## Product Change Notification / KSRA-09NSTT965

CCB 4251 Initial Notice: Qualification of MTAI as an additional final test site for selected Atmel ATF16V8Bxx device family available in 20L PDIP package.

## CCB 4251 PRE AND POST CHANGE SUMMARY

**Qualification of MTAI as an additional final test site for selected Atmel  
ATF16V8Bxx device family available in 20L PDIP package..**

# TUBE for G6X 20L PDIP 0.300in

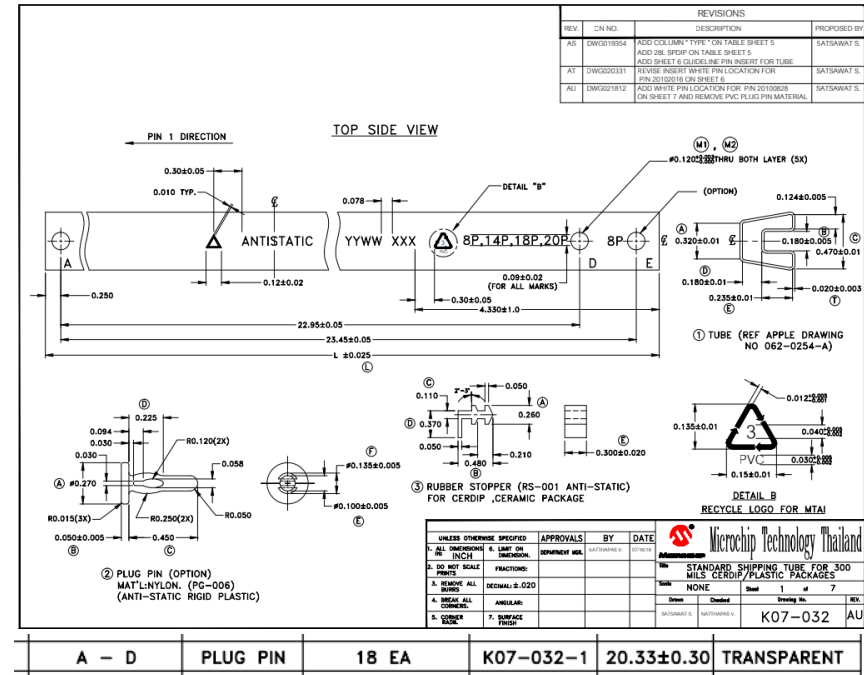
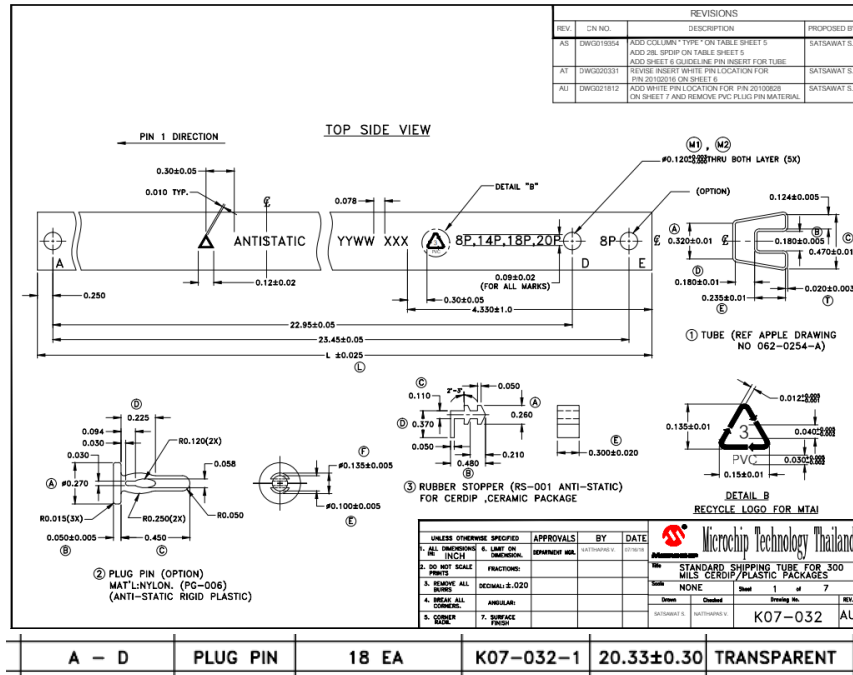
Plant	Dimension A	Dimension B	Dimension C	Length	Thickness	Color
MPHL	0.180+/-0.01in	0.320+/-0.01in	0.235+/-0.01in	20.33 in	0.020+/-0.003in	Transparent
MTAI	0.180+/-0.01in	0.320+/-0.01in	0.235+/-0.01in	20.33 in	0.020+/-0.003in	Transparent

# TUBE Packing method for Package G6X 20L PDIP 0.300in (MSL: N/A)

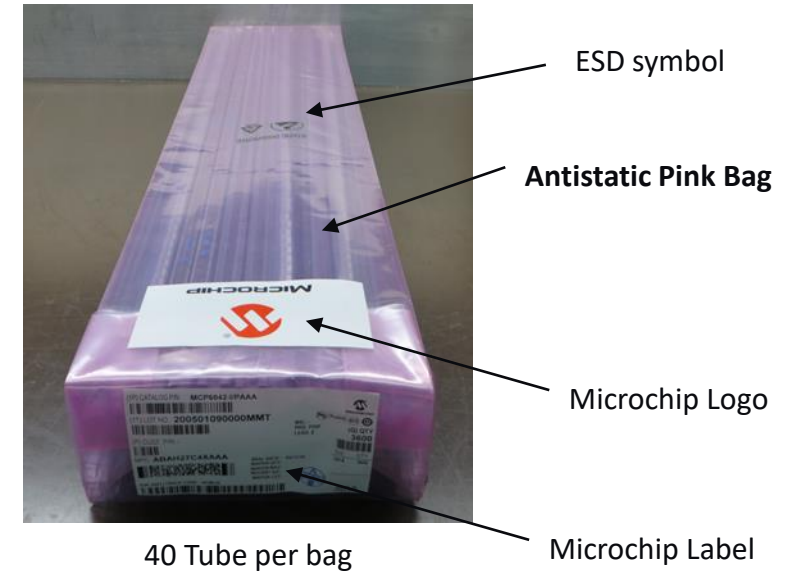
Carton	Dimension W x L x H (cm)	Number of Bag/carton
M01-020 (PD)	15x71.5x5	1
M01-021 (PI)	17x65x8	1
M01-022 (PP)	15.5x62x14	2
M01-023 (PT)	22.5x63x16.5	3
M01-024 (P4)	32x63x15.5	4
M01-034 (P5)	36x63x16.5	5
